DRAFT WORK PLAN FOR DISPOSAL OF DYE BURIAL GROUNDS DYE-IMPACTED WATER SOLID
WASTE MANAGEMENT UNIT #02/11 SEPTEMBER 1998.

COMMENT • RESOLUTION

Comments by: NSWC Crane EPD

**DISPOSAL OF DYE BURIAL GROUNDS
DYE-IMPACTED WATER**

FIGURE I-2
 LOCATION OF DBG (SWMU #02/1 1)

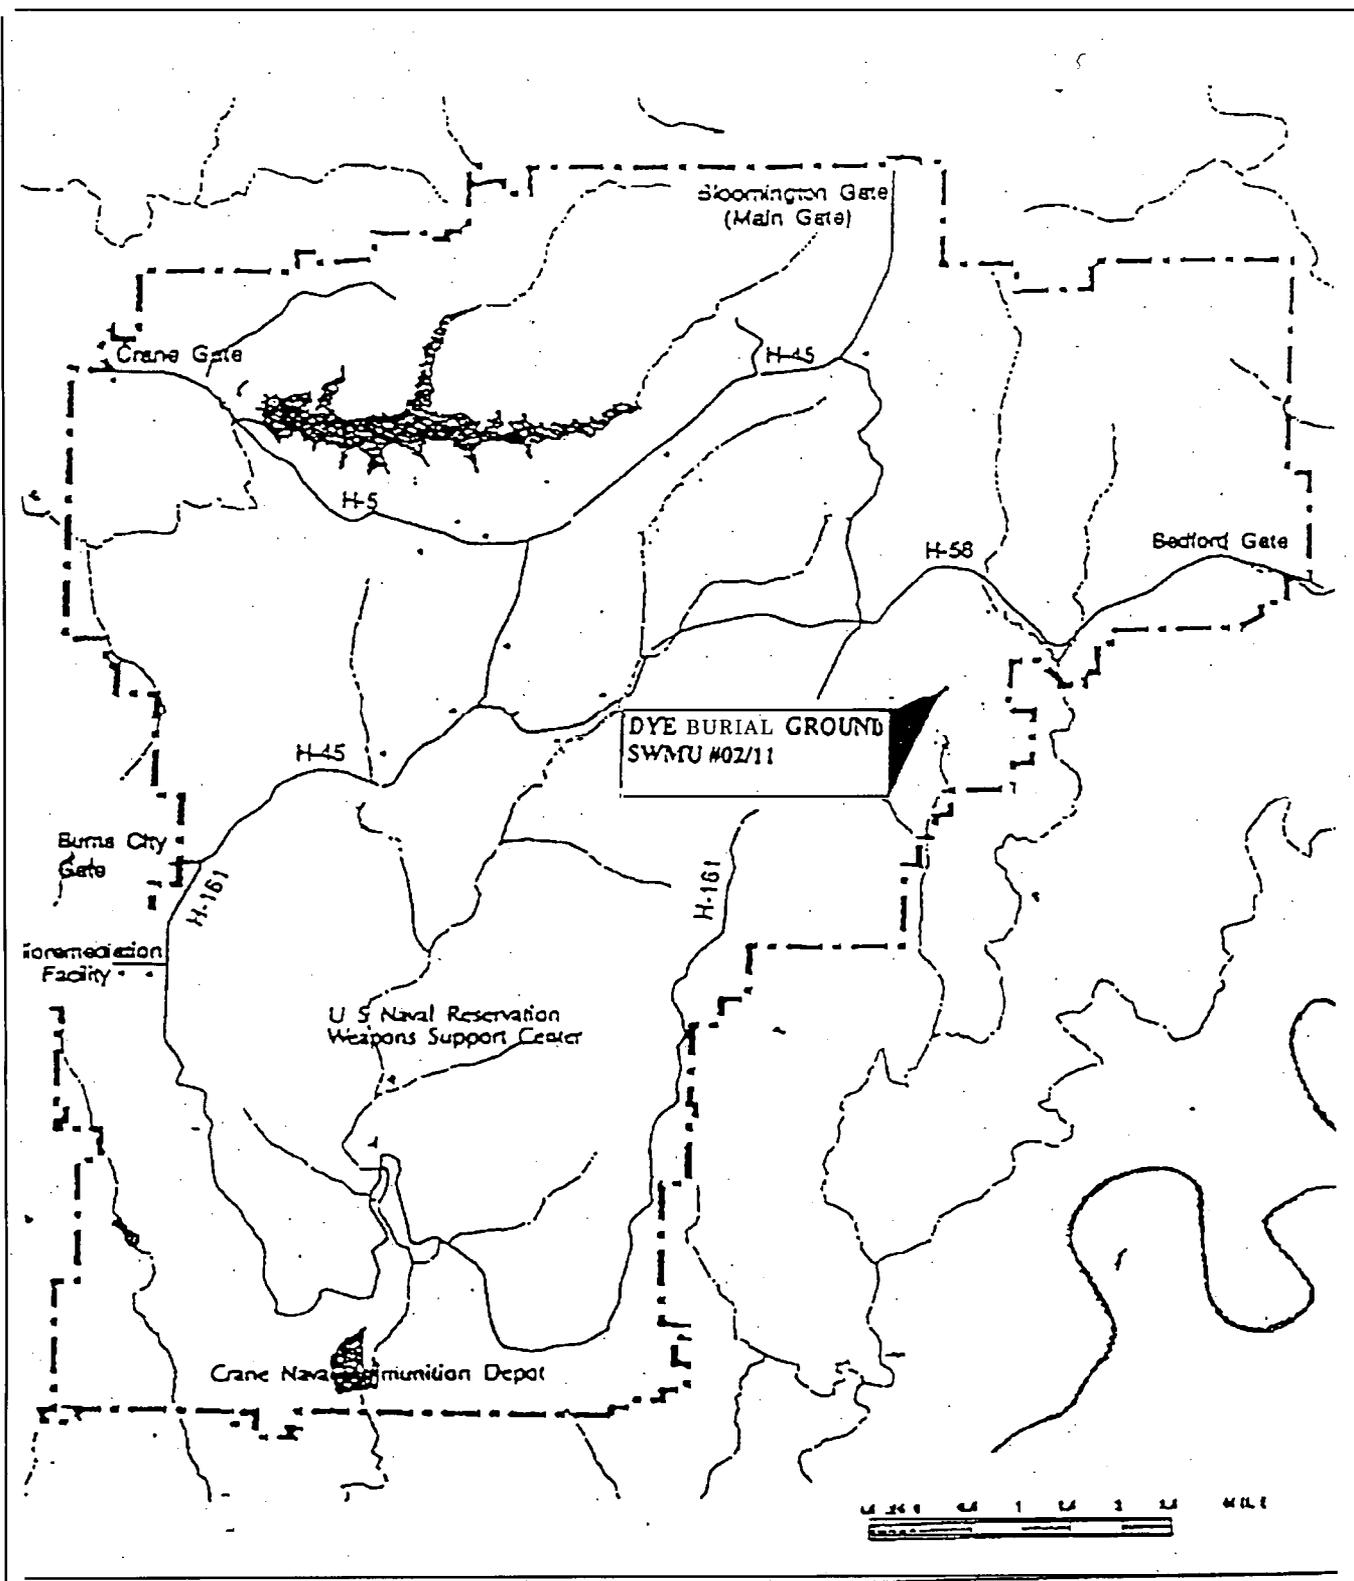
Comment 4: p.1-4 Figure 1-2
Provided that the issue can be resolved in time, the point of discharge into the sanitary sewer should be noted on this figure.

Response 4: Comment noted. The discharge point will be documented on this figure (if available) or will be included in the IMR.
